## Stability of land at Windermere, East Tamar.

An area [EQ010261], referred to the Department of Mines by the Town and Country Planning Commissioner as Proposal Plan Ld 179, and owned by Mr E.A. Hill was examined on 14 March 1974. It constitutes a building block of about 0.2 ha between Windermere Road and the River Tamar. An adjacent area of about 8 ha upslope on the north side of the road was examined at the same time. Both areas are dealt with in this report (fig. 1).

Figure 1. Land at Windermere, showing evidence of landslip.

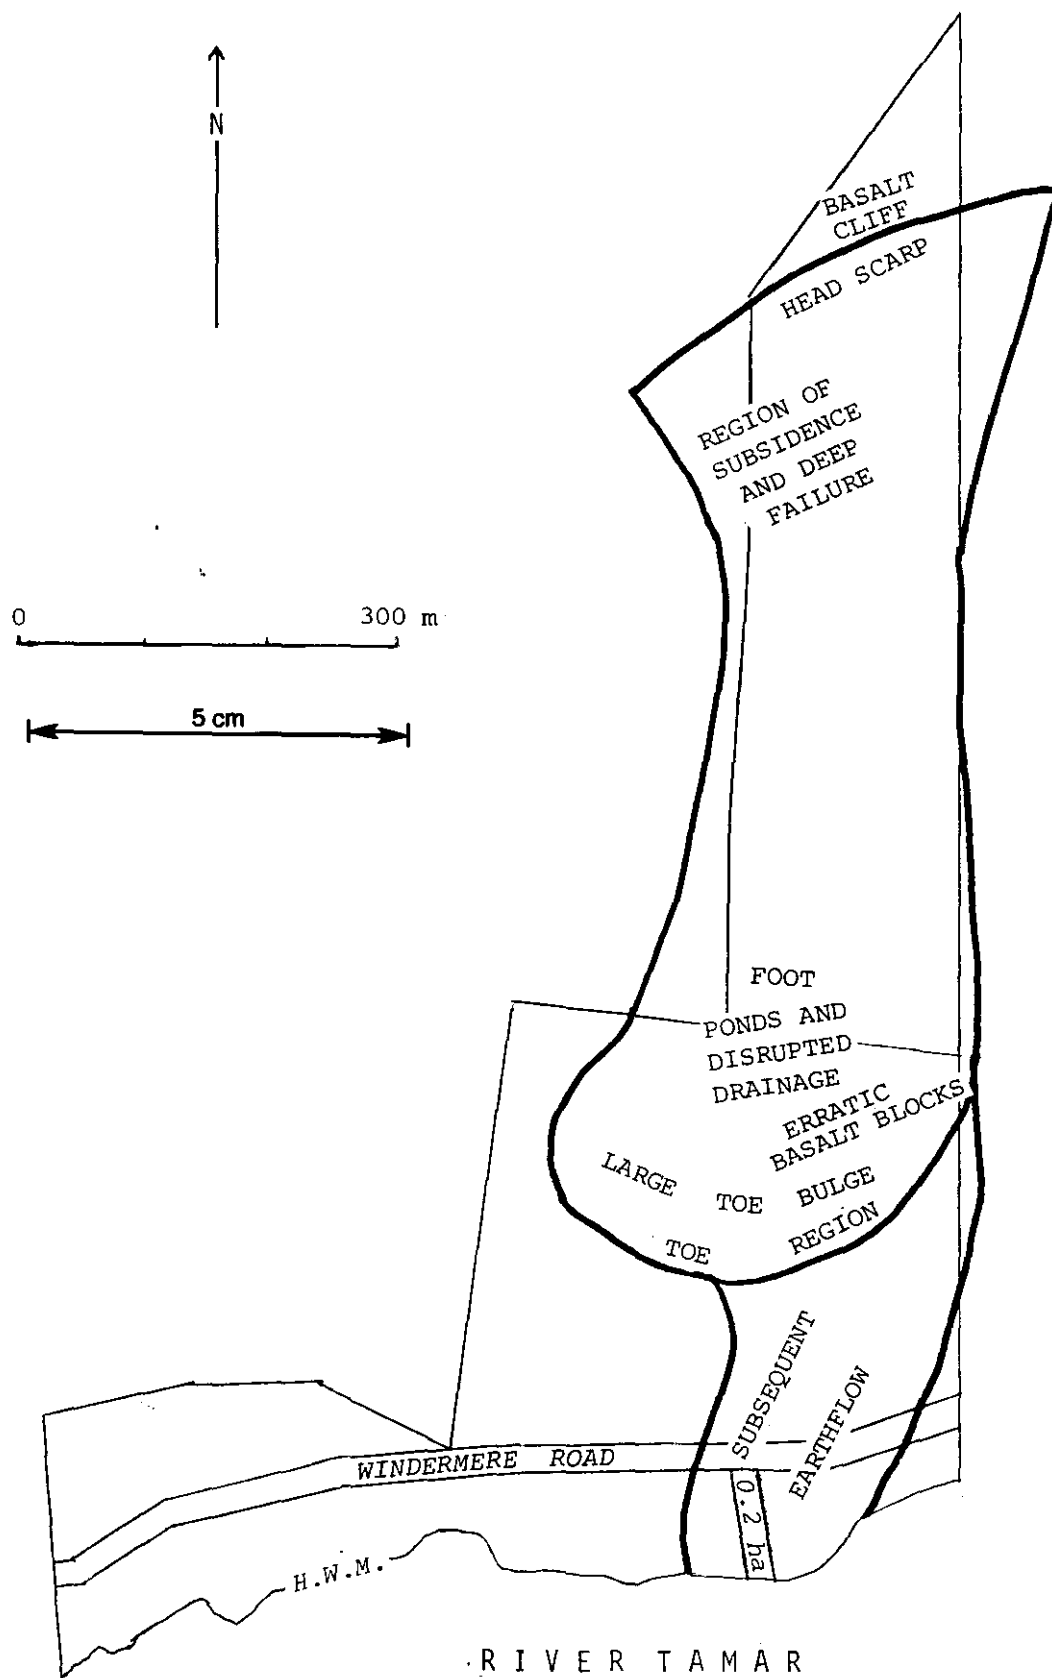
The strong ridge of hills to the north of the area is formed of a layer of basalt. This is underlain by a series of soft sands and clays, and although they are rarely exposed they are known throughout the Tamar Valley as a cause of landslips. The action of rainfall percolating down through the basalt and softening the clays has produced some hundreds of landslips in the Valley and a major feature of this kind may be seen running down from the basalt ridge across the 8 ha area as far as the river (fig. 1).

The irregular contours, hummocky ground, the ponds and generally disturbed nature of the watercourses, the large transported basalt blocks and the high basalt scarp above all point to a major disturbance in the recent geological past. This may readily be sketched from aerial photographs as has been done in Figure 1.

Large landslips of this kind are active for periods of many decades and often develop earthflows from the toe region as has been suggested in the sketch. The activity of this earthflow may continue long after the main slip has been stabilised and this very late minor activity may account for some of the features seen in the house block.

All these features, taken together with the presence of white plastic clays cropping out on the shore, and the history of landslipping on the slope above indicate that any building on the block must be undertaken with full knowledge of the hazards and the greatest care taken in the construction of foundations and in the design of water supply pipes and drains. The generally low slope of the block is a hopeful character, but earthflowed material often has a strength considerably less than its original strength, and it is subject to further loss of strength in the presence of excess water.

Figure 2. Portion of Tamar Valley Landslip Zone Map.

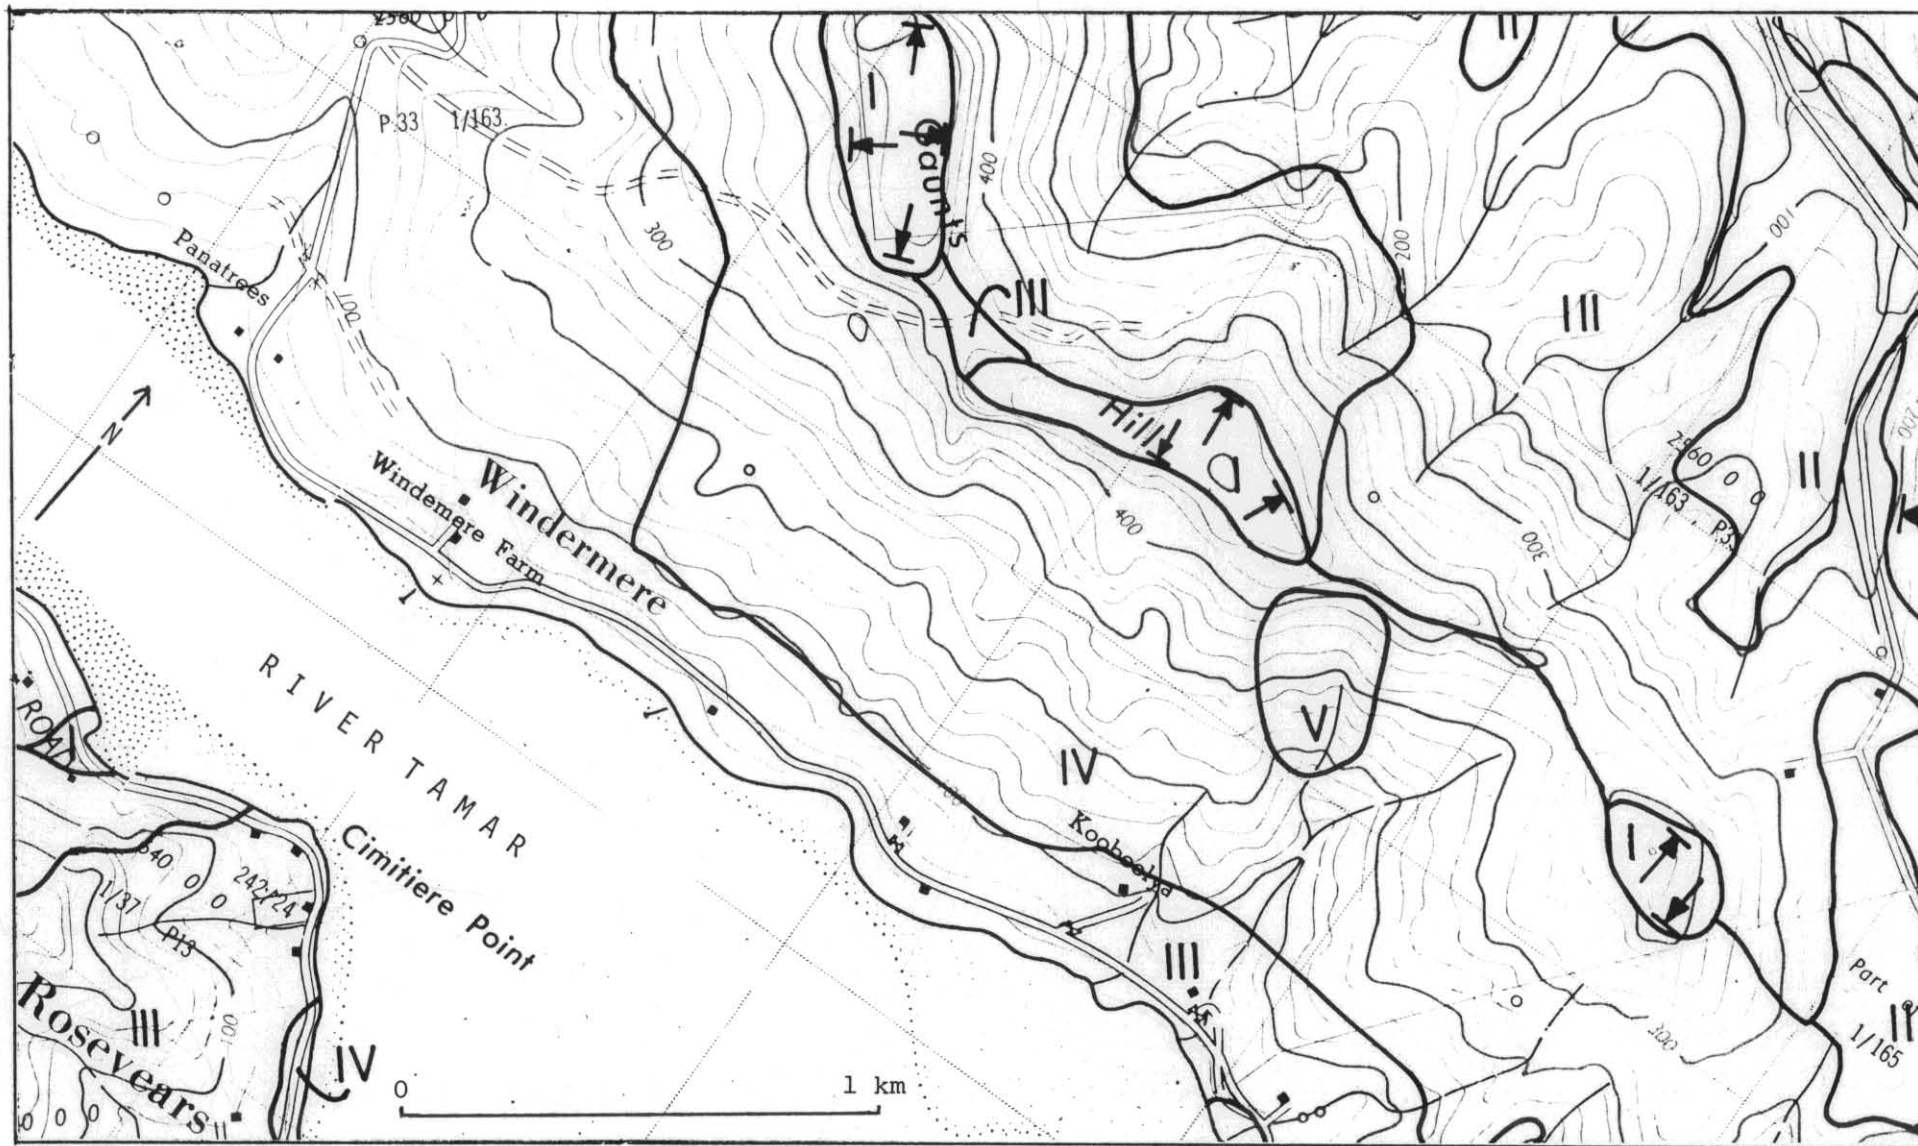
The whole region has been zoned as Zone III (Potential Landslip area) or Zone IV (Old Landslip area) on the Tamar Valley Landslip Zone Map. An extract of this map is appended as Figure 2.
